A D D E N D U M

Project No.: 2501101
Project: EACS Restroom Renovations

Addendum No: 02
Date: 04/02/2025

ADDENDUM NO. 02, to Drawings and Specifications dated 03/12/2025, for the EACS Restroom Renovations for the East Allen County Schools; as prepared by ELEVATUS Architecture, 111 E. Wayne Street, Suite 555, Fort Wayne, IN 46802

Reflected Ceiling & Finishes Plans - First Floor

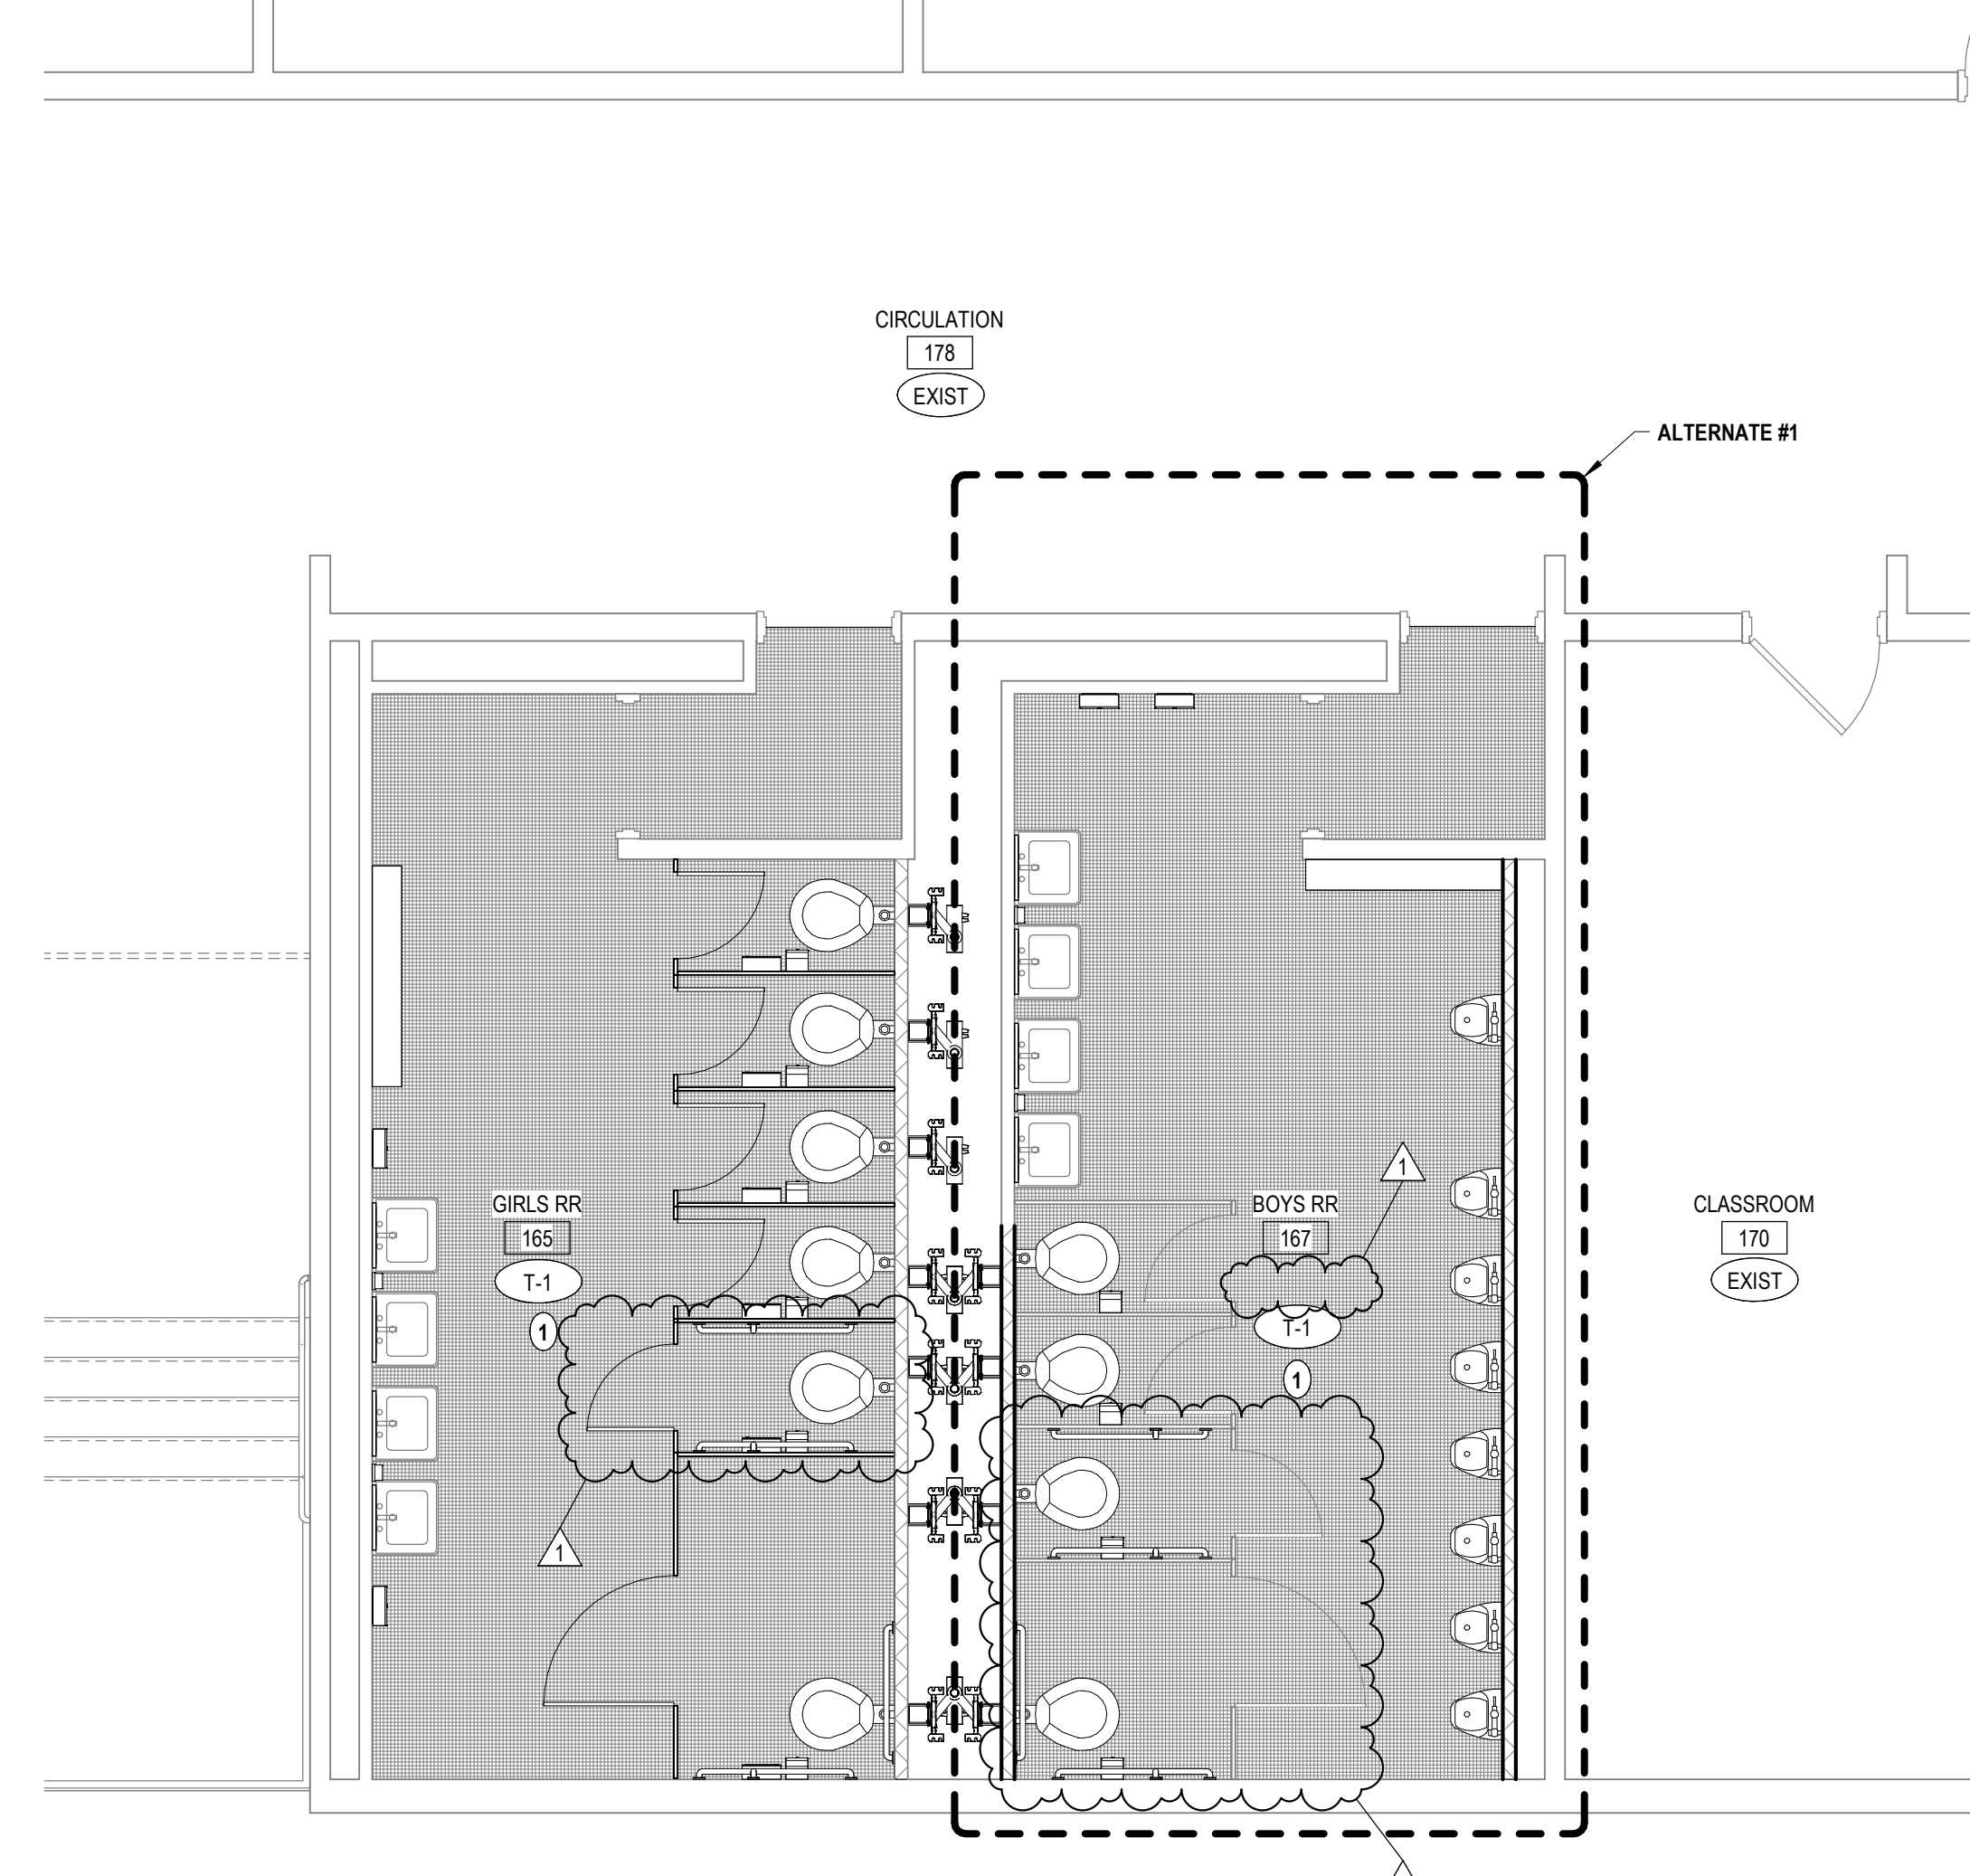
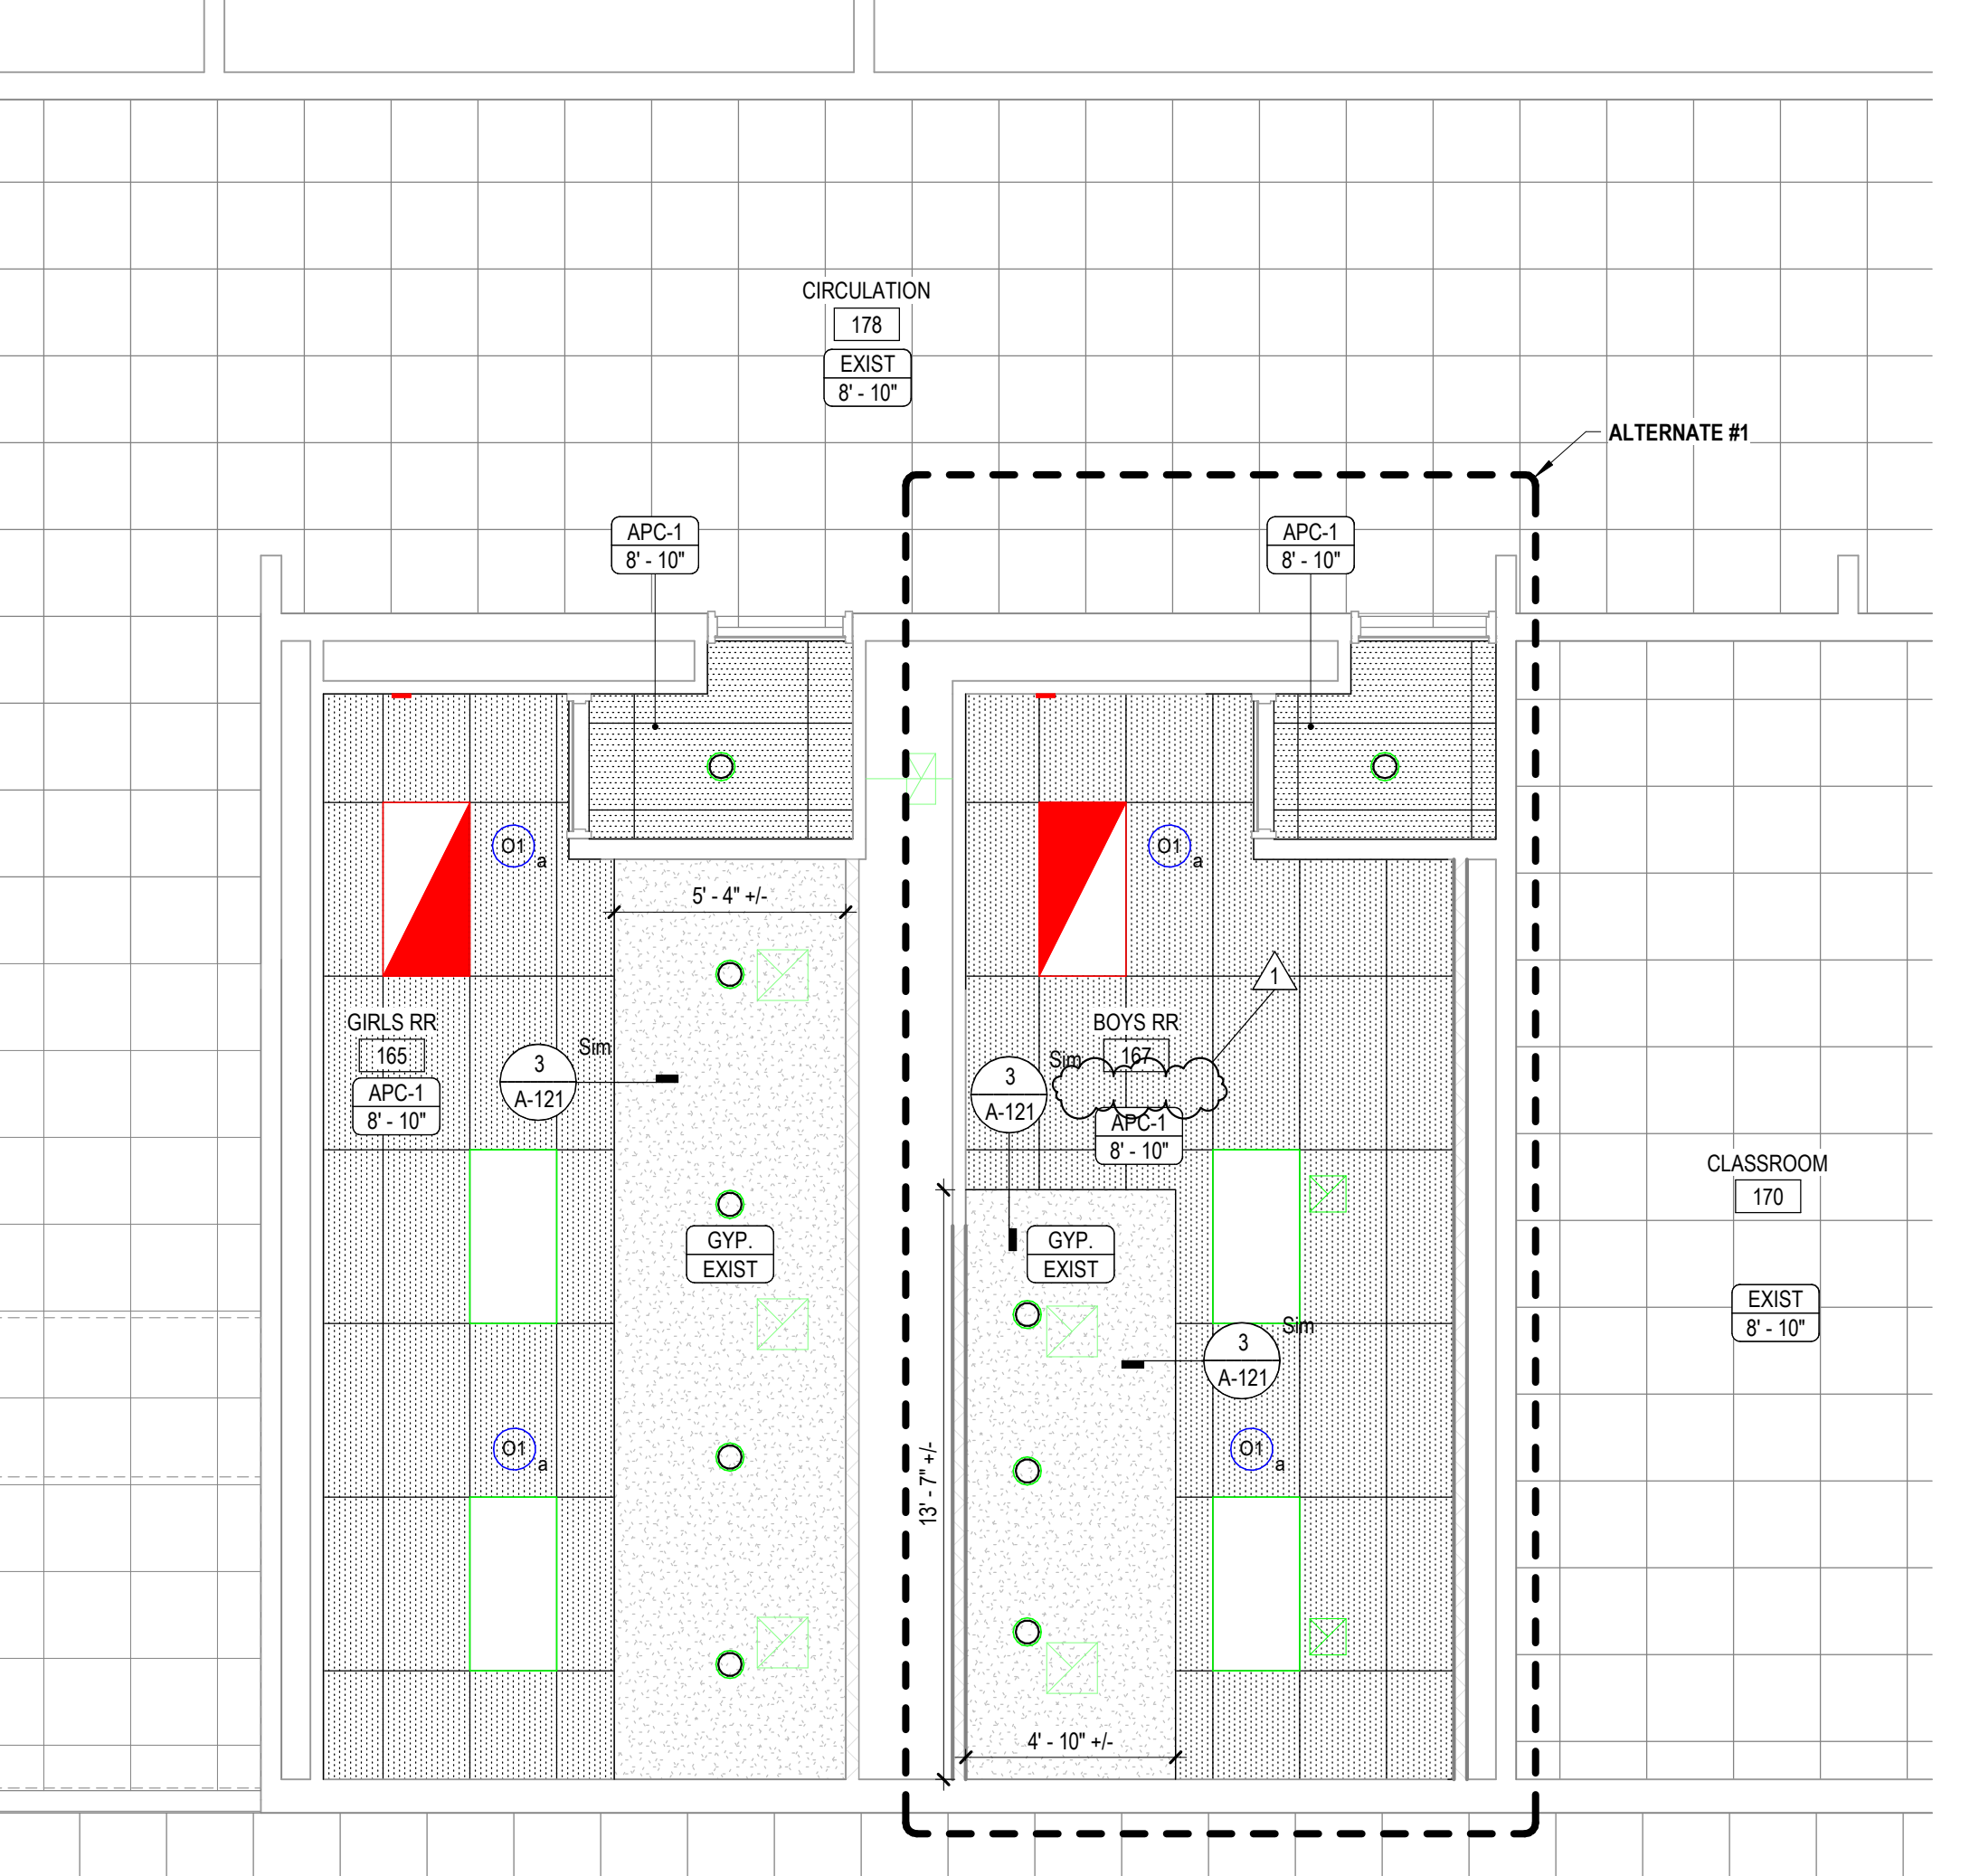
ITEM NO. 1.04 - DRAWING NO. A-121 Reflected Ceiling & Finishes Plans – First Floor

- A. Removal of "Alternate #1" text from Boys RR room on First Floor Reflected Ceiling Plan.
- B. Removal of "Alternate #1" text from Boys RR room on First Floor Finishes Plan.
- C. Revision of toilet partition layout in Girls RR and Boys RR rooms on First Floor Finishes Plan.
